CITY OF TACOMA

ADDENDUM NO. 2

DATE: November 12, 2019

**Request for Bids Specification No. PW19-0306F
TACOMA FIRE STATION #5**

WORK ORDER NO. W019-0157
KPF# NO. 1900060
SHEET NO. **WO-5**
SHEET 5 OF 9

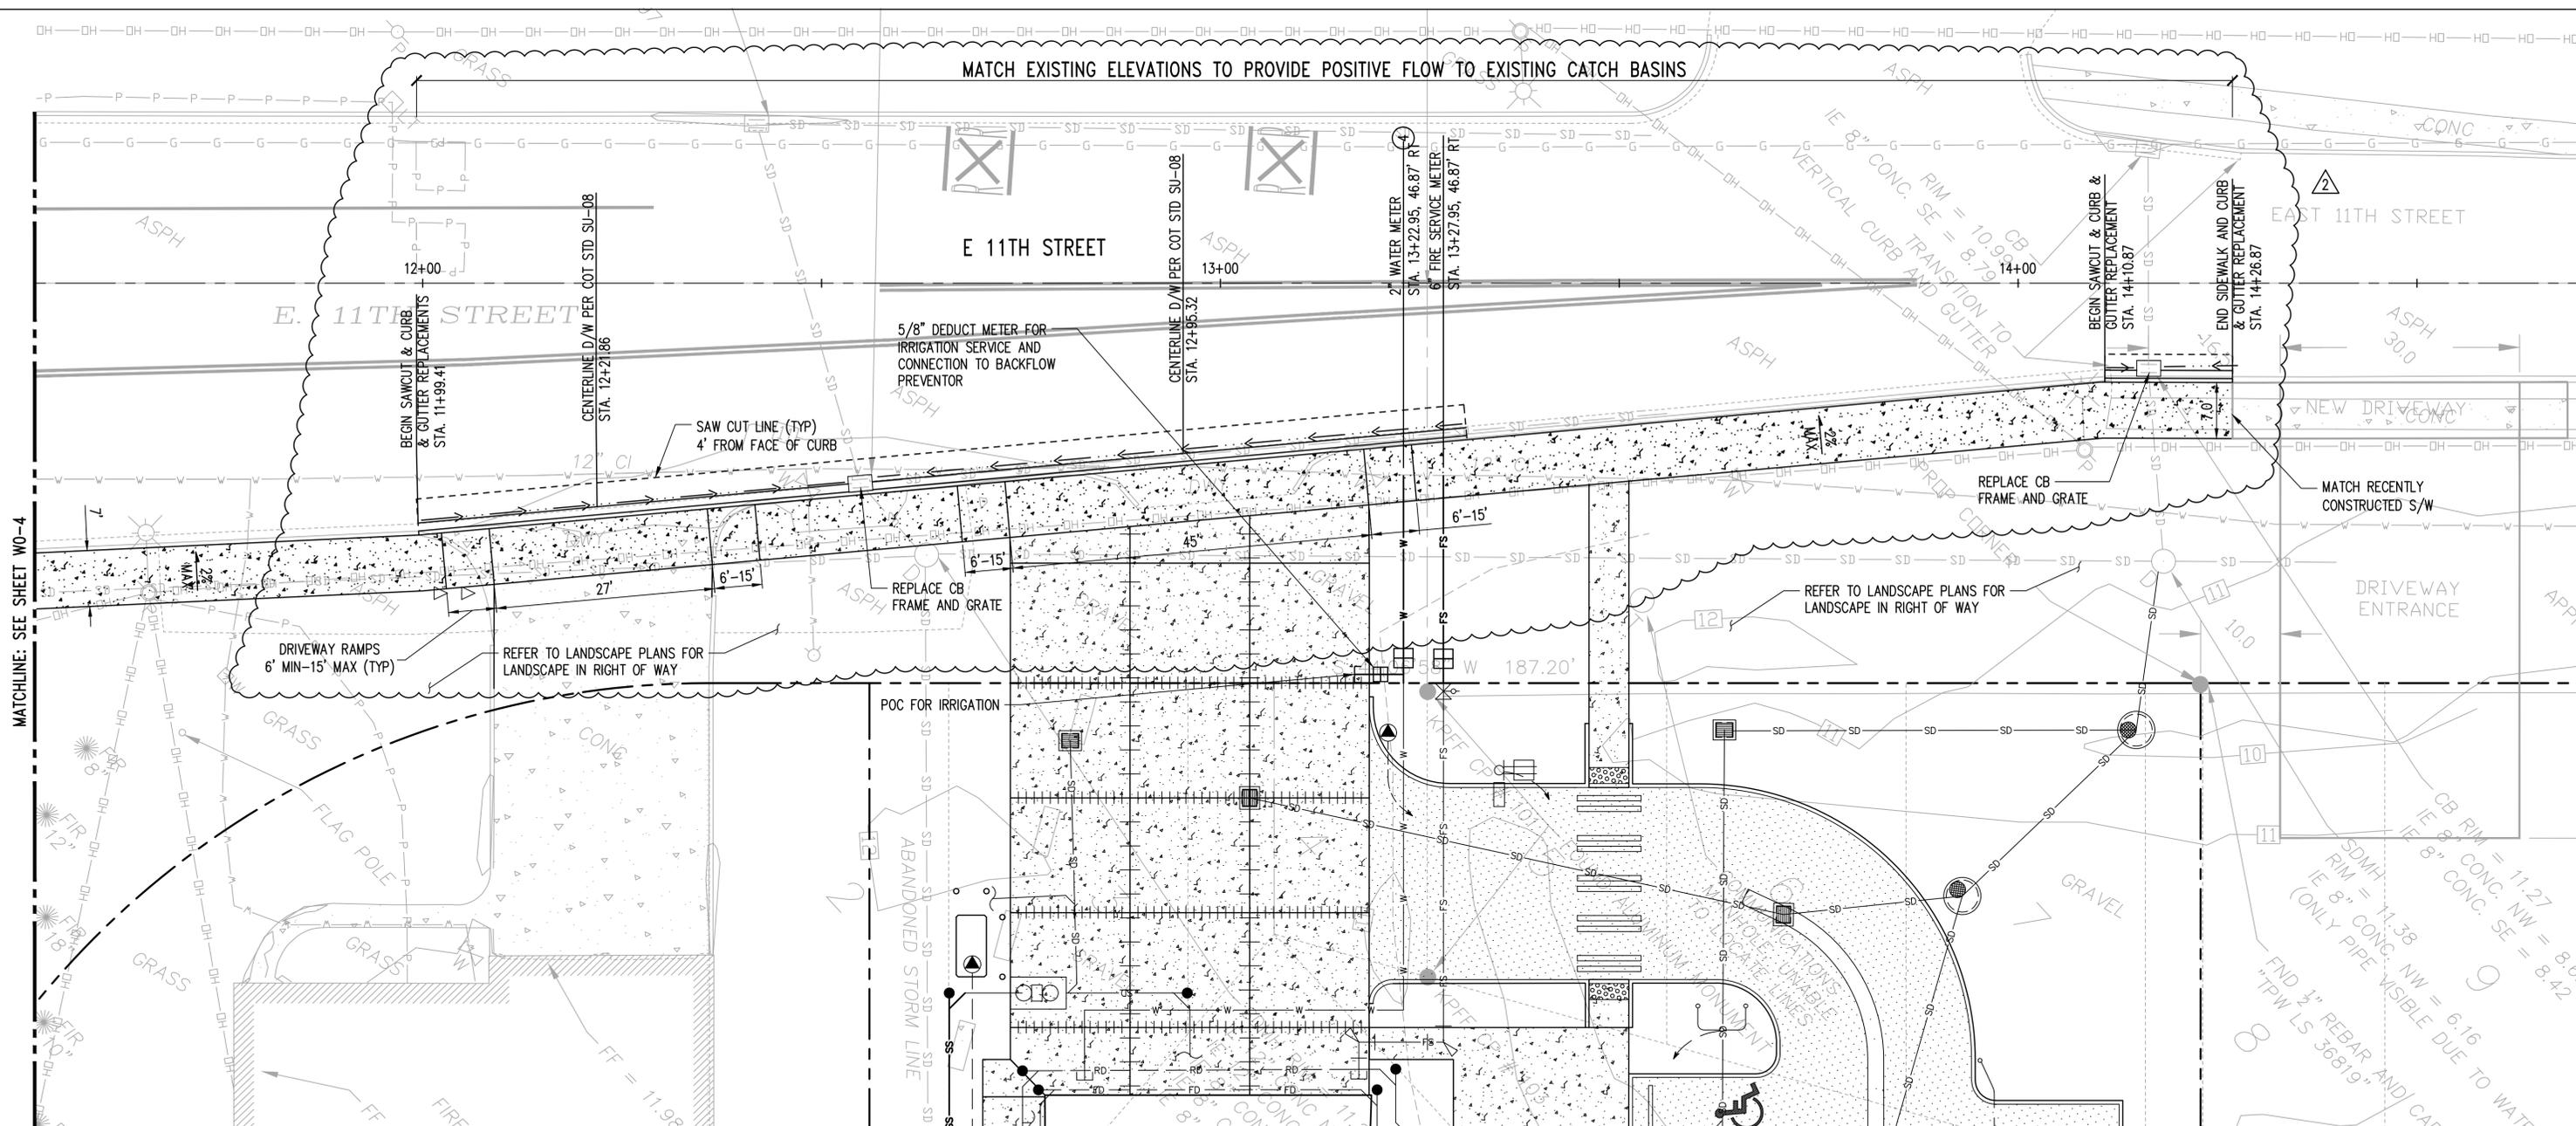
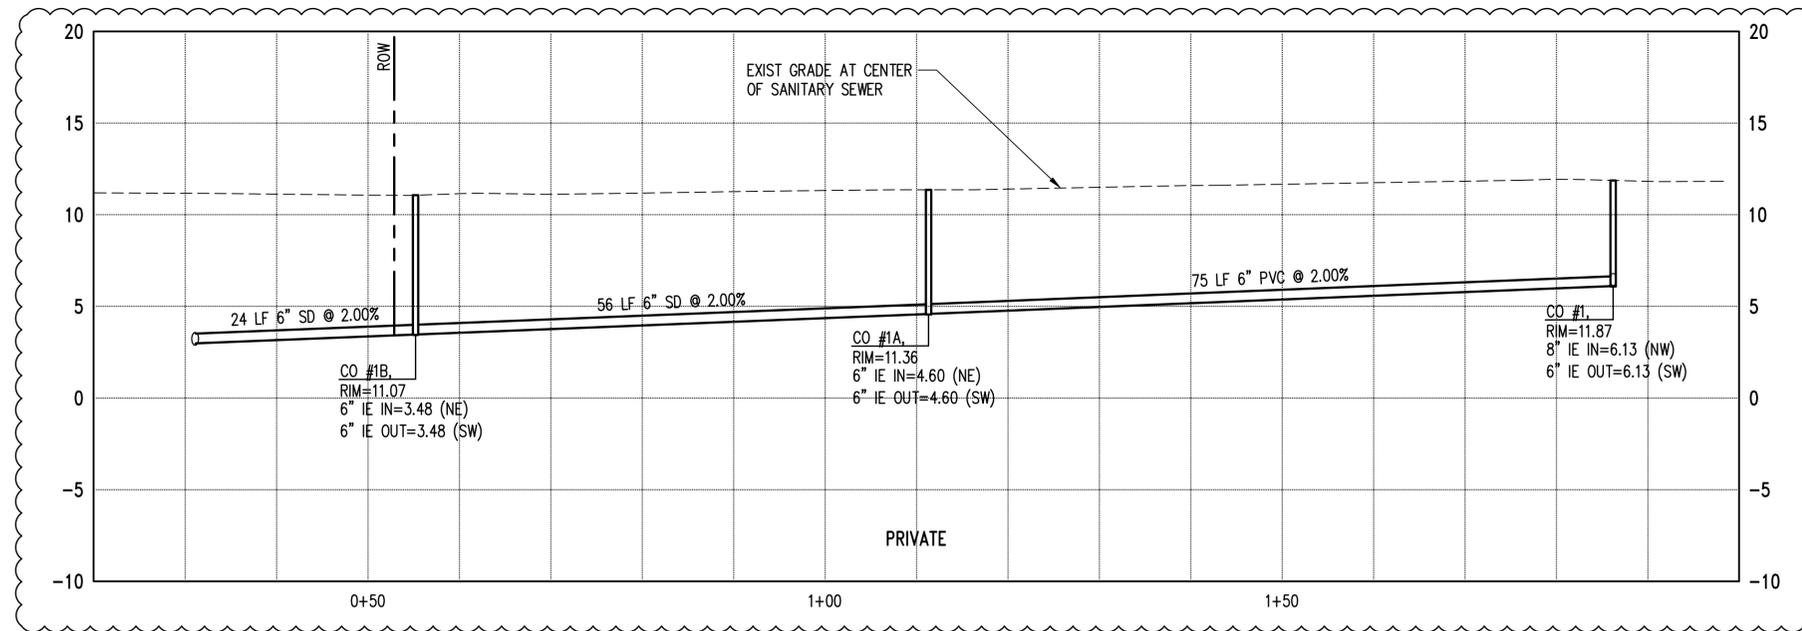
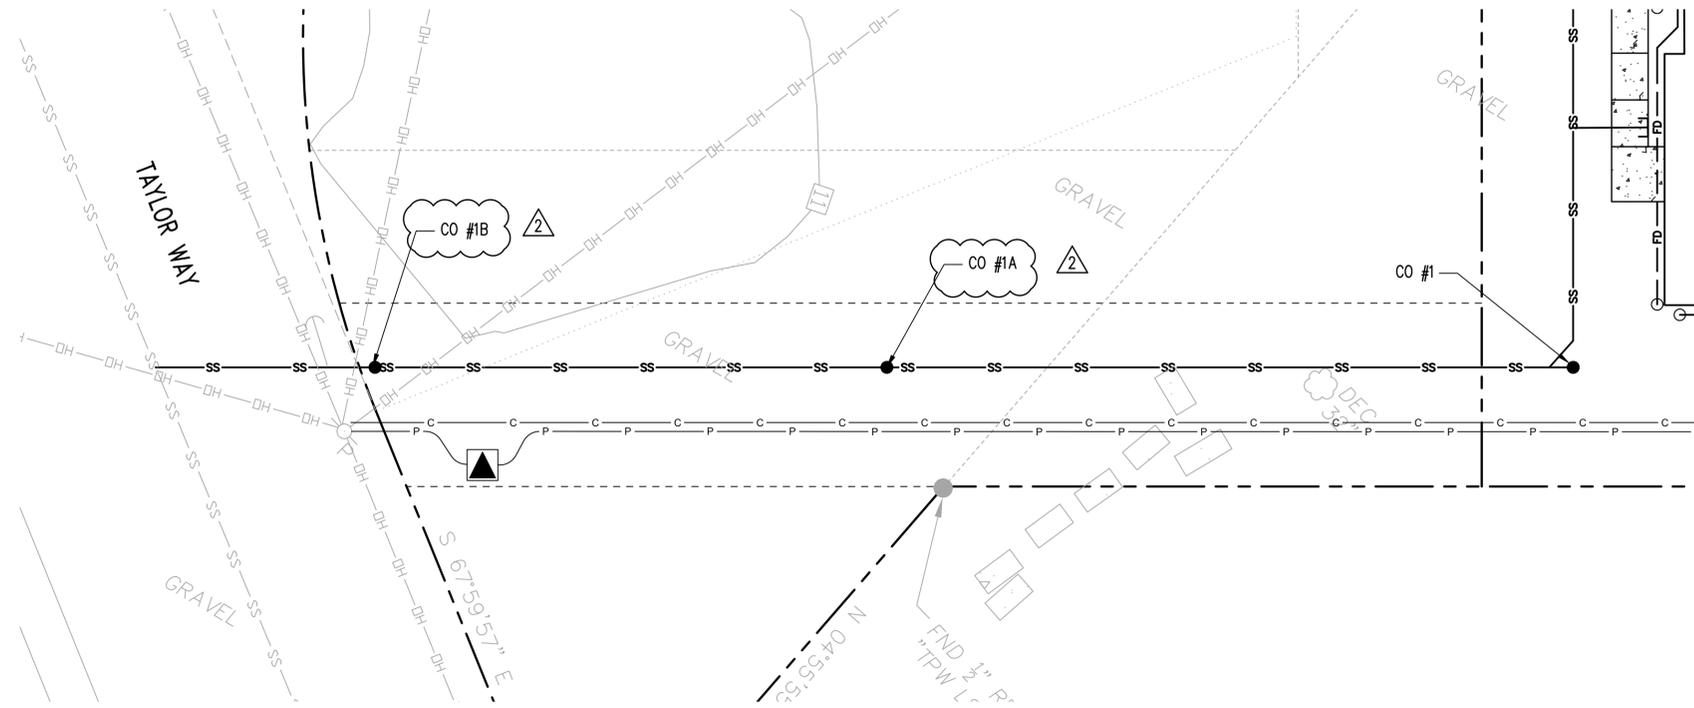
SHEET WO-05 SIDEWALK, DRIVEWAYS, AND SERVICES (as shown on re-issued sheet C4-1, and identified as Addendum 2 in the revision portion of the title block)

ADD: Note to read "2% max slope" to address the sidewalk cross-slope.

ADD: "7.0" dimension to the sidewalk.

REVISE: dimensions to increase the driveway ramps to ensure slope does not exceed 8.3% max

ADD: Note to read "Match existing elevations to provide positive flow to existing catch basins"

MATCH EXISTING ELEVATIONS TO PROVIDE POSITIVE FLOW TO EXISTING CATCH BASINS

Typical Downspout Bracket

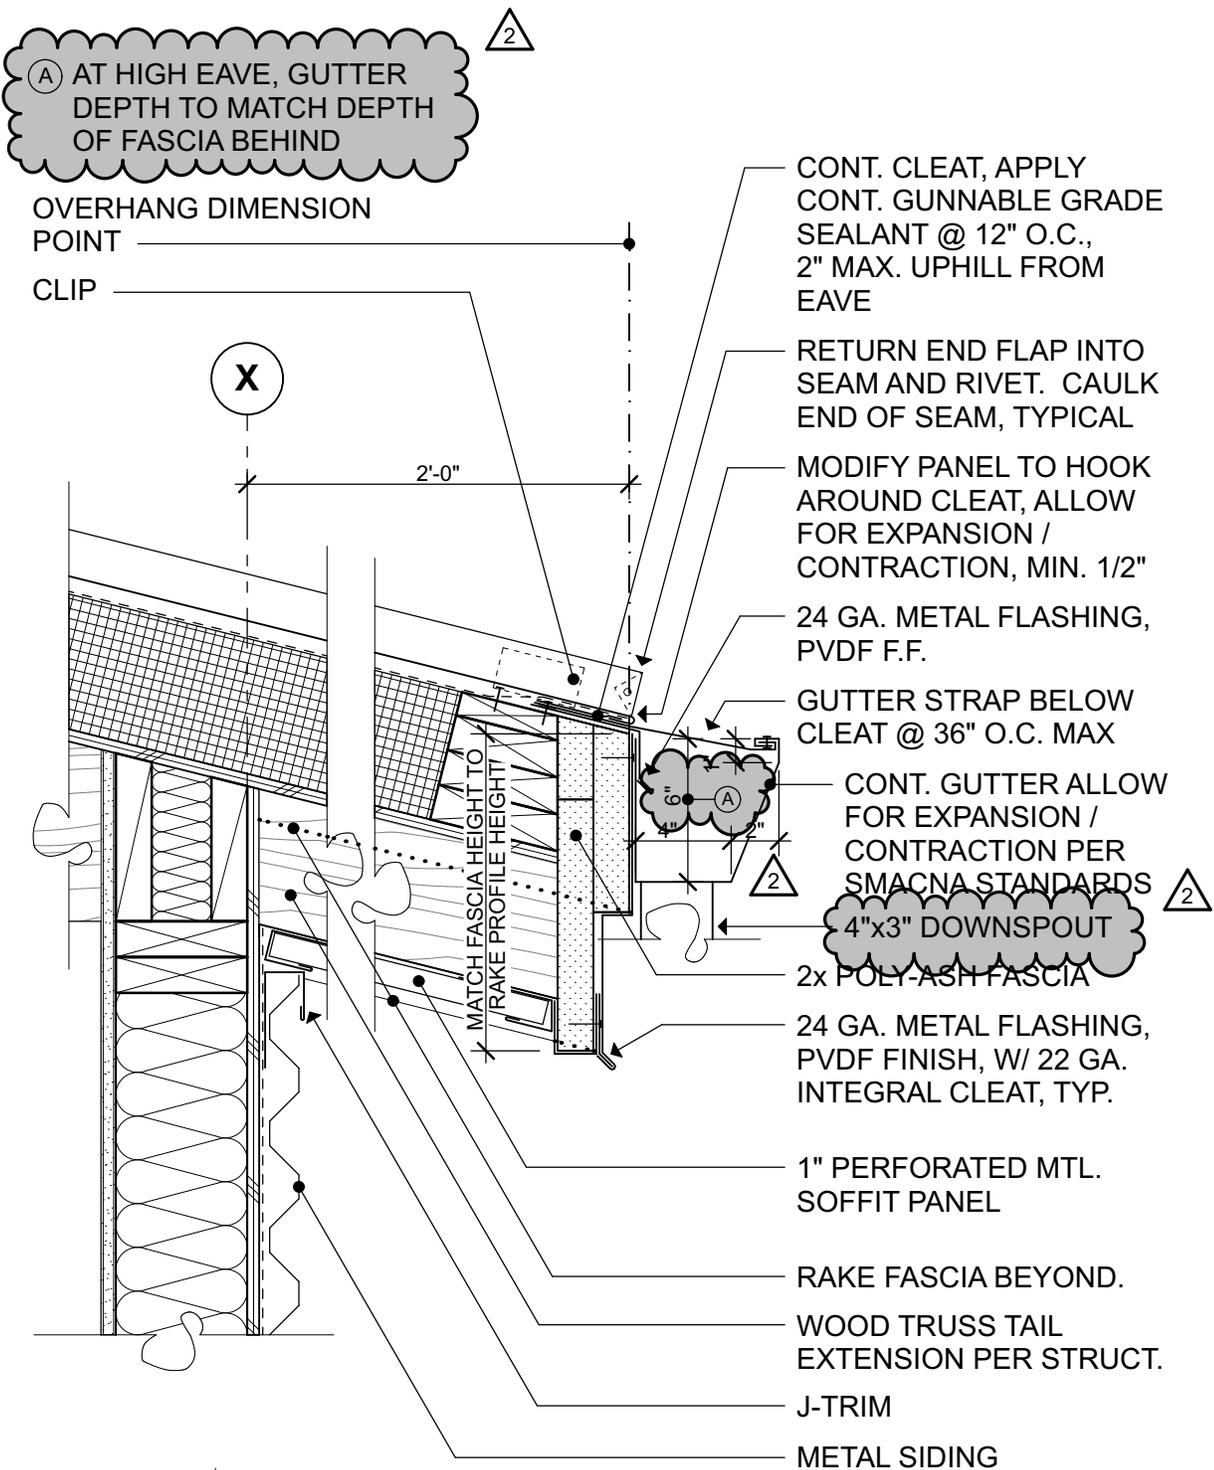
ADD: Detail 1 to clarify typical downspout bracket detailing as shown on Addendum drawing SKA-1.

Typical Low Eave

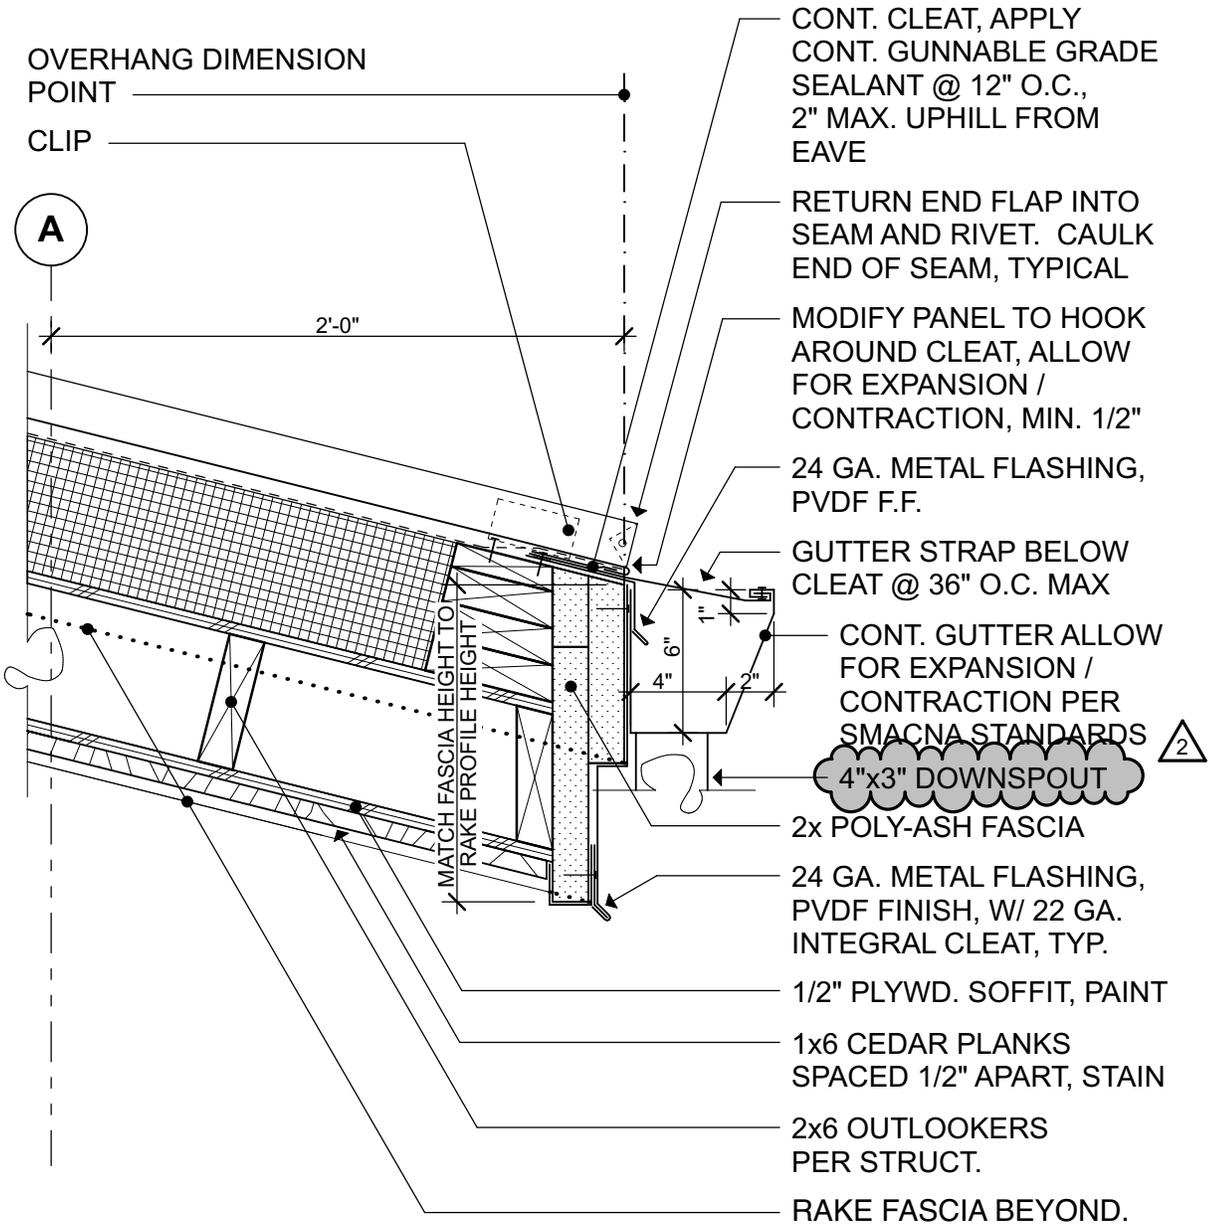
REVISE: Details 12 & 13 to add notes and revise downspout size as shown on Addendum drawings SKA-2 and SKA-3.

RPBA Assembly

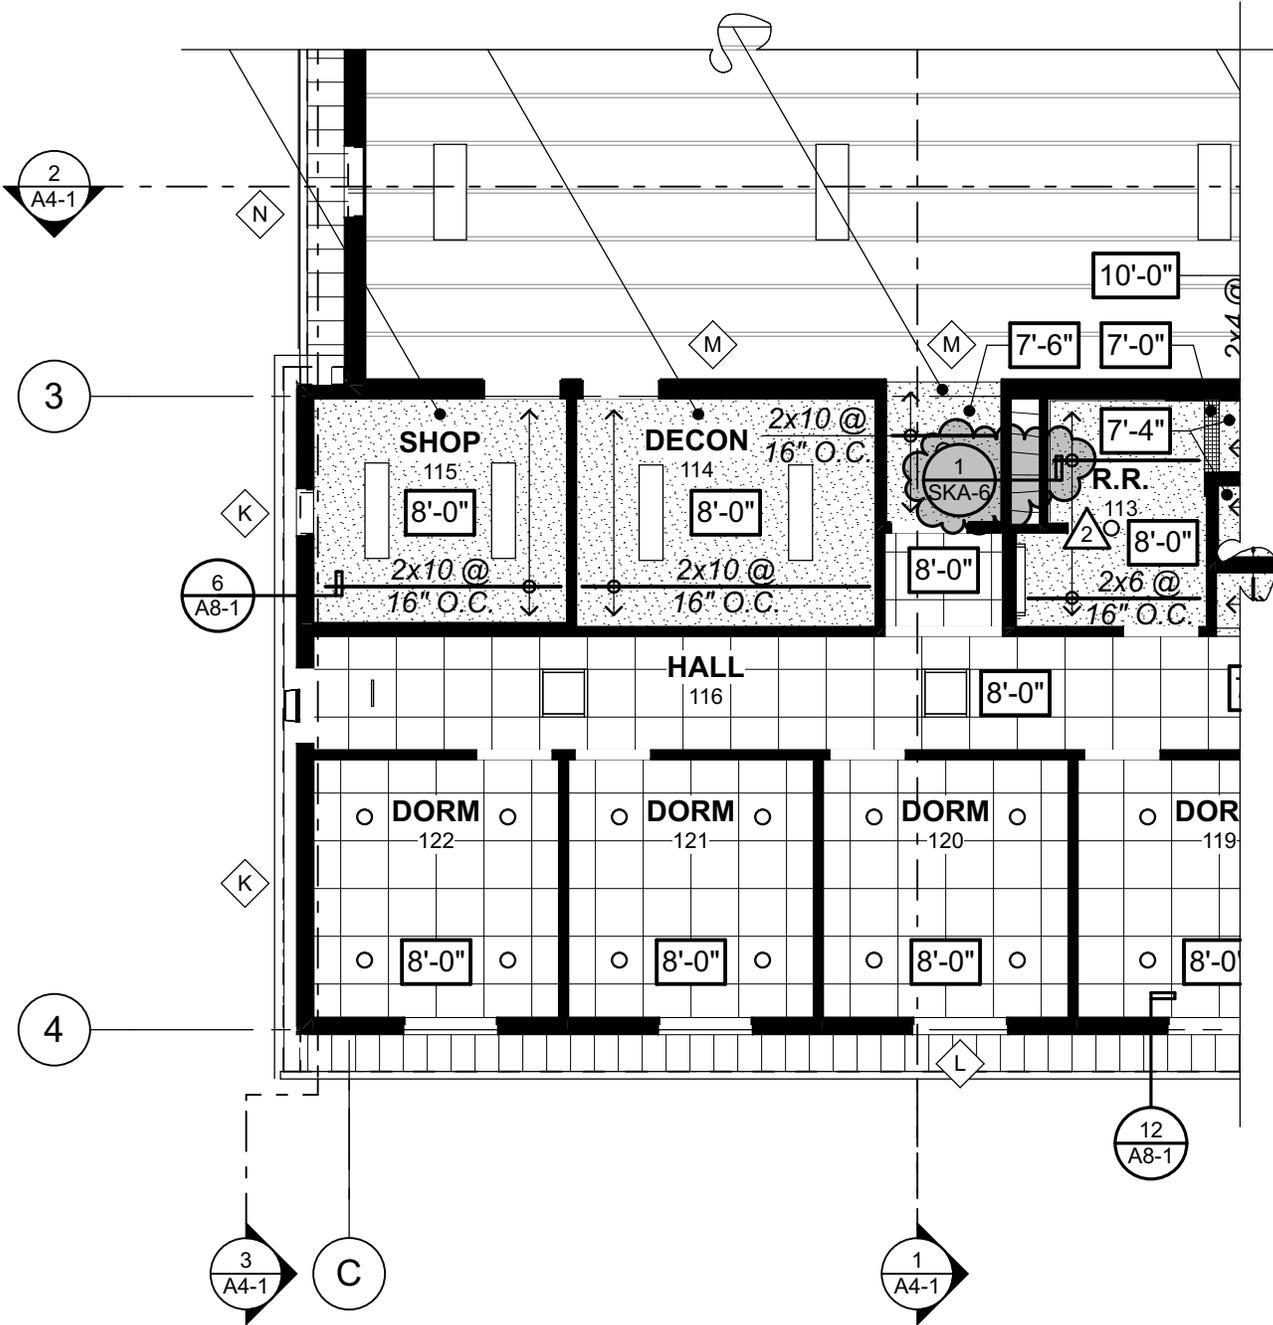
ADD: RPBA in the Apparatus Bay as shown on Addendum drawing SKA-4.
